## **Additional Information for Removal of Optional Tail Skid Weight**

**STC# SR09248RC Tail Rotor  
Flapping Bearing Kit (LB2-1010-  
20-1) for use on Bell 206A,  
206B, 206L, 206L-1, 206L-3,  
206L-4**

**SIL\_LB2-1010-20-1**

**SUBJECT:** Additional information on removal of optional tail skid weight Y-27316-44-1

**FIGURE 1**

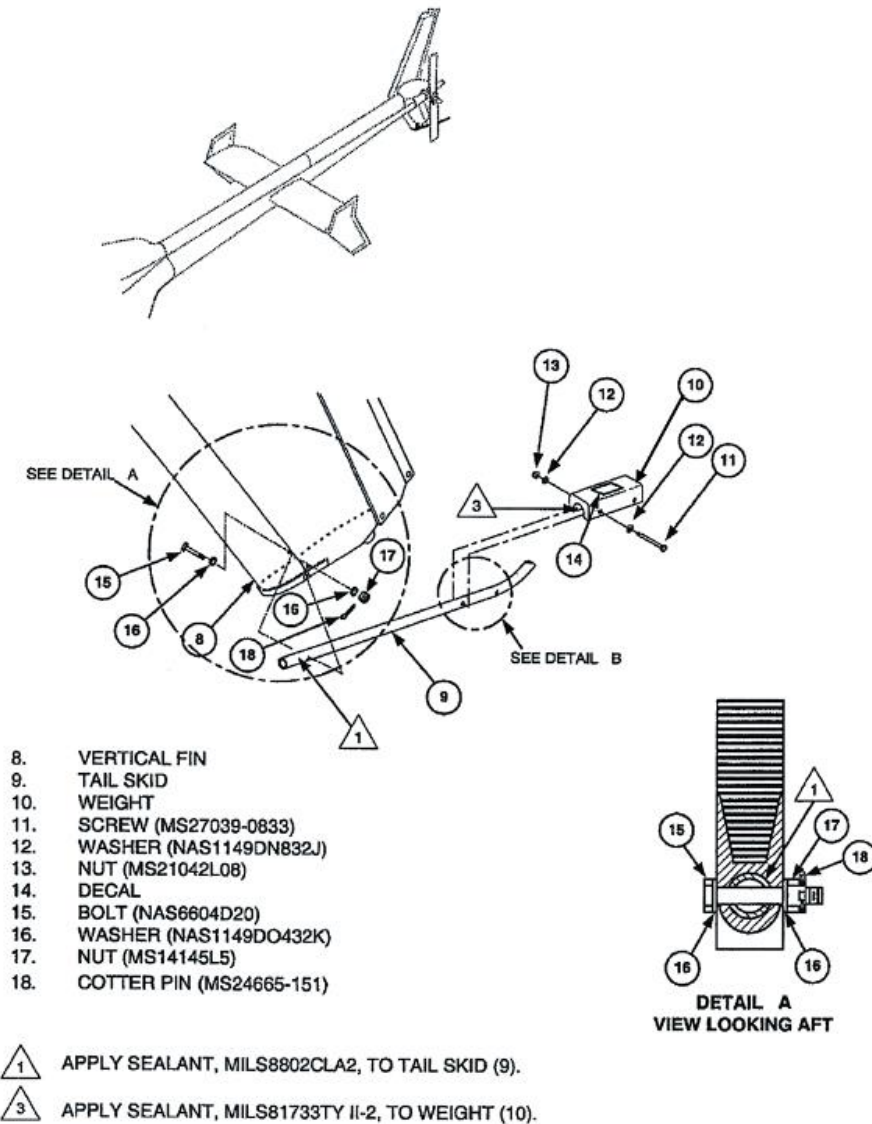
1. If you prove that the tail rotor can be dynamically balanced without the weight installed for service (See Reference #2), disassemble the tail skid weight from the tail skid. Reference Figure 1 below.

2. Keep the tail skid weight (10) for possible future use.
3. Remove any excess sealant that may still be present at the interface of the previously installed weight and tail skid.

**FIGURE 2**

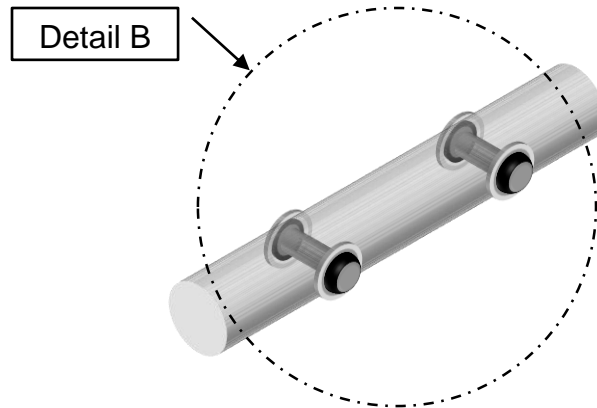
4. Install commercially available shorter length screws, with the same or new washers and nuts through the machined holes in the tail skid as shown in Figure 2 below. The purpose of the re-installed hardware is only to fill the gap left by the machined holes.

5. Dynamically balance the tail rotor as specified in the Bell Maintenance Manual. If the dynamic balance is acceptable, apply sealant around the interface of the hardware and tail skid to complete the assembly.
6. Make any necessary entries in the helicopter log book and component historical records.
